Project Name: *Chals West Village*

PRELIMINARY PLAN FOR TRAILS WEST VILLAGE
 IN SECTION 18, T1S, R1W, U.M.
 A PART OF THE SW 1/4 SECTION 18, T1S, R1W, U.M., MESA COUNTY, COLORADO.

Subject: Grand Junction Planning STAFF REVIEW/ANALYSIS
Preliminary Plan-Trails West Village, File #PP-95-157

FILE: #PP-95-157
DATE: January 3, 1996
STAFF: Kathy Portner
REQUEST: Preliminary Plan--Trails West Village
LOCATION: E of S. Camp Road, S of S. Broadway
APPLICANT: Camelot Investments, LLC

MAJOR BASIN DRAINAGE MAP OUTLINE
 Proposed TRAILS WEST VILLAGE SUBDIVISION
 REDLANDS AREA, GRAND JUNCTION, CO.

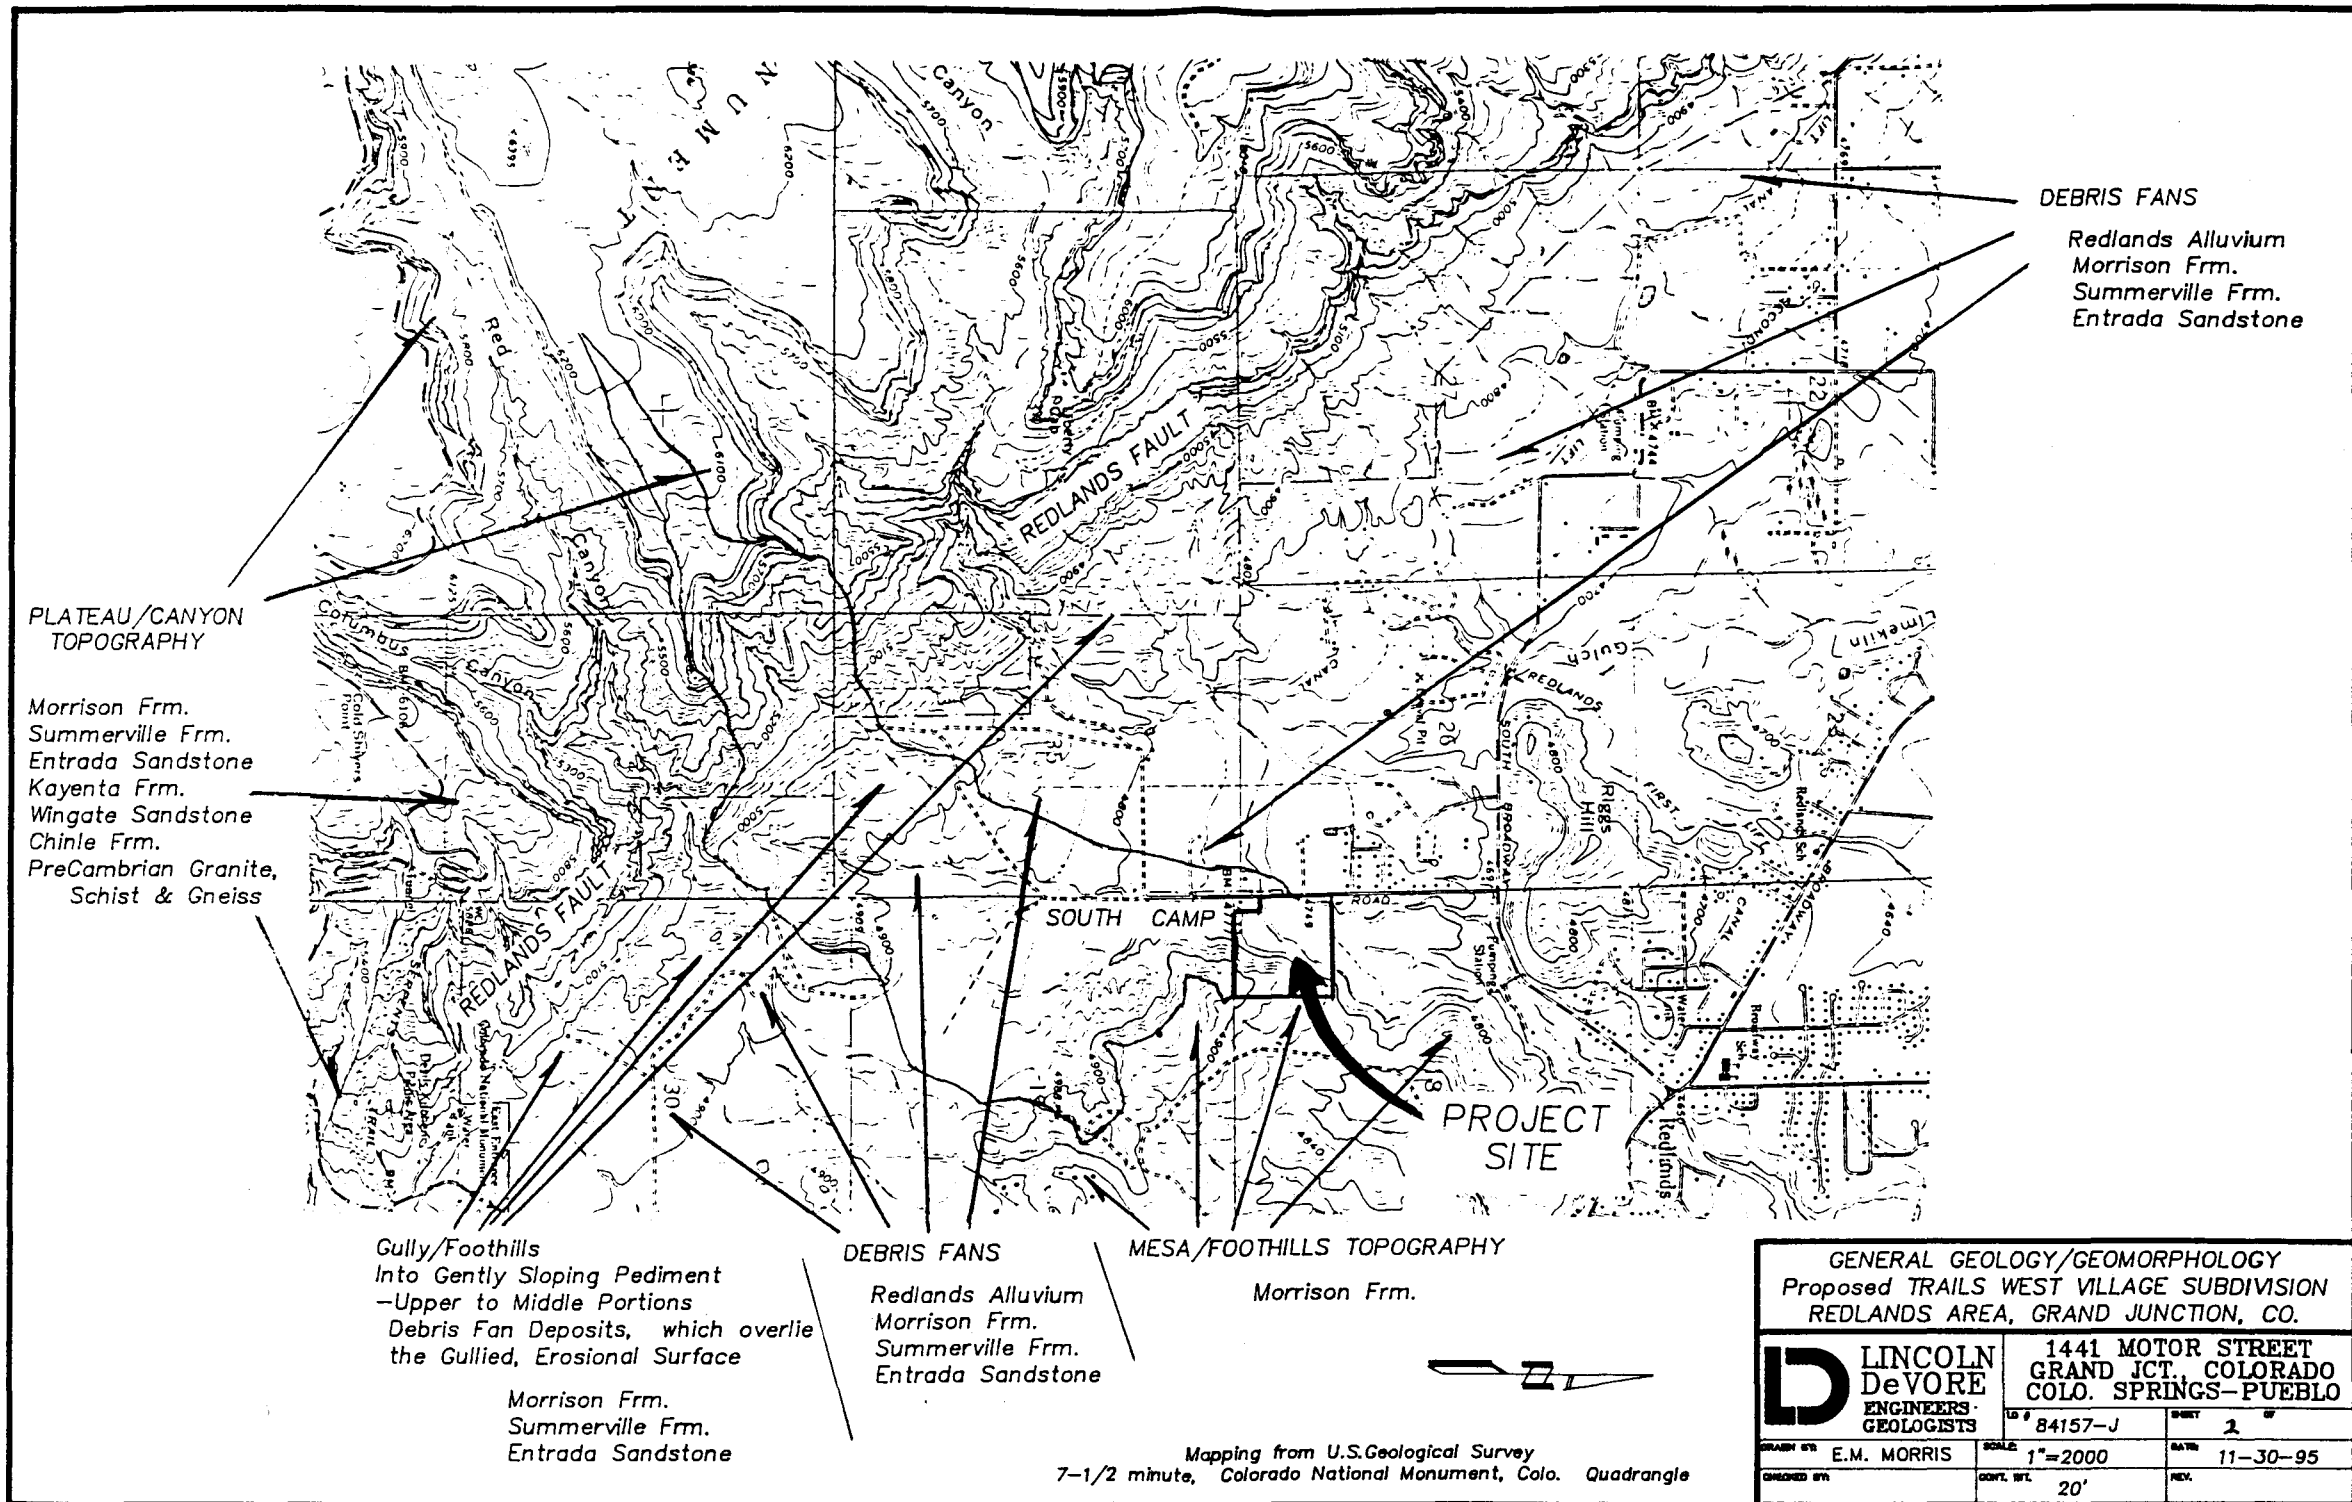
11. Did not address the off-site contribution of drainage. Drainage report and plan not in accordance with SSID requirements.
12. Detention areas not shown.
13. Copies of prior drainage reports not included in response.
14. Geotechnical report not complete. Did not make specific recommendations for road cuts, pavement design or rock fall structures that may be required.
15. Have not adequately justified having a cul-de-sac far exceeding the recommended maximum length of 1,000 feet.

Response: See response to number 4, above. Petitioner's studies reveal that approximately 150 cfs could pass through the culvert under South Camp Road in a worst case scenario. The channel design for this situation is reflected in Exhibit N.

Roadway plan and profile
with stationing.

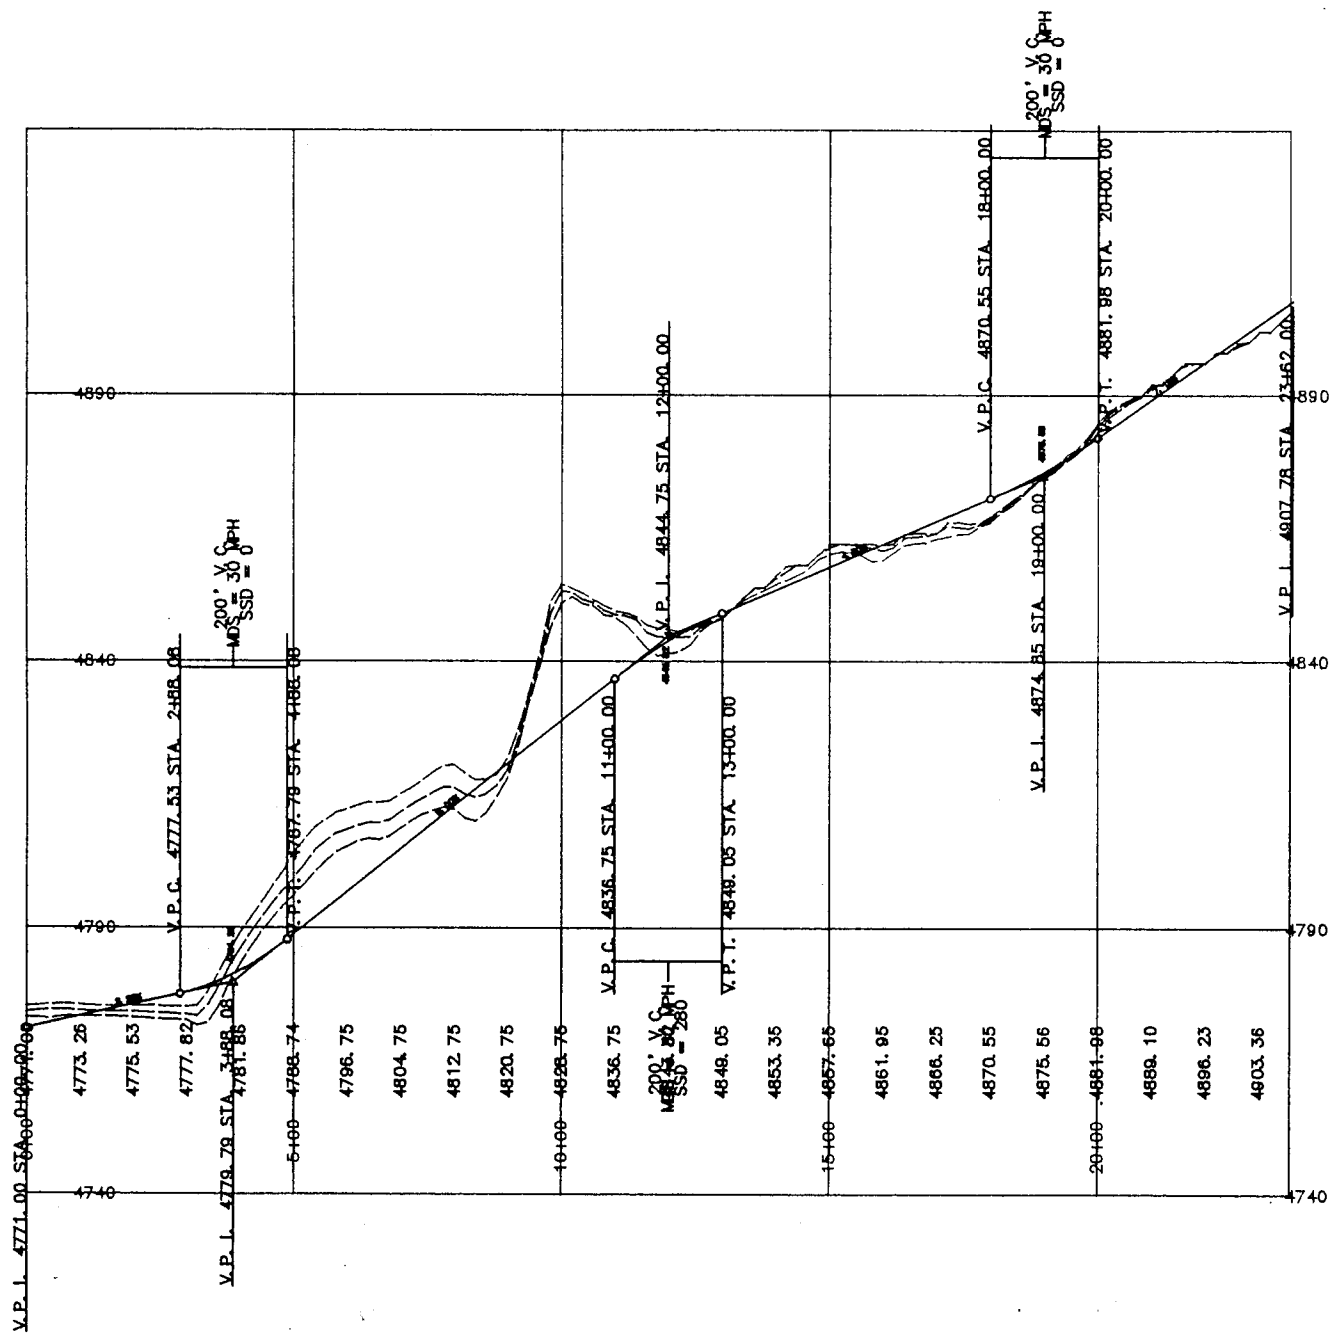
4. The extend of the floodplain, as identified by the Mesa County Planning Staff comments must be shown and detailed as to the plan for that area.
5. A revised roadway plan and profile with stationing was not submitted.

Response: A revised roadway plan and profile with stationing is submitted as Exhibit N.

Post-It® Fax Note	7671	Date	12-5-95	# of pages	1
To	Paul Stowell PE	From	Ed Morris PE		
Co./Dept.		Co.			
Phone #	973-2040	Phone #	242-8968		
Fax #	973-972-2724	Fax #	970-242-1561

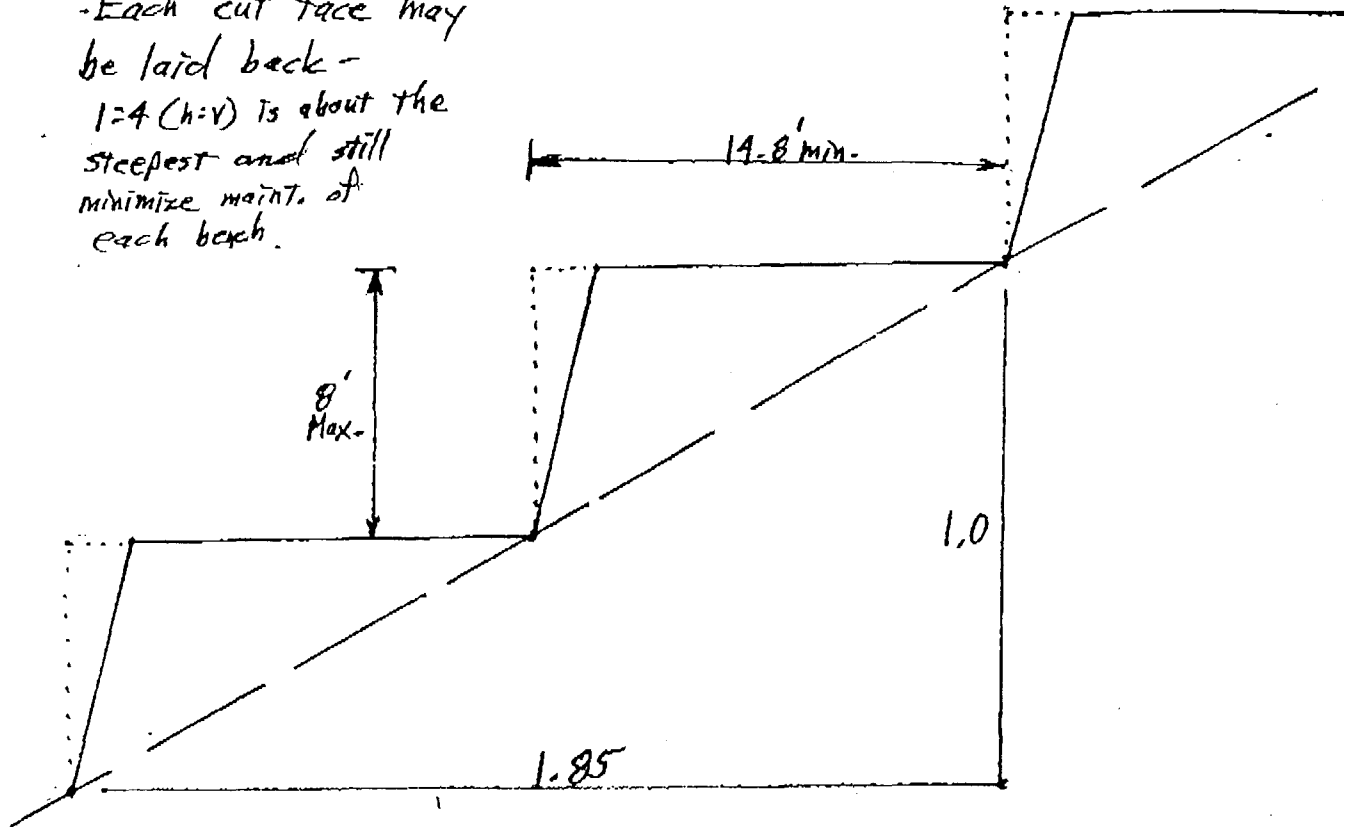
6. Detail was not submitted on the proposed cut areas to determine if the design is feasible. It also was not shown how the cuts could be lessened.
7. Inadequate geotechnical information to determine if slope stability can be attained.

-Each cut face may be laid back -
 1:4 (h:v) is about the steepest and still minimize maint. of each bench.
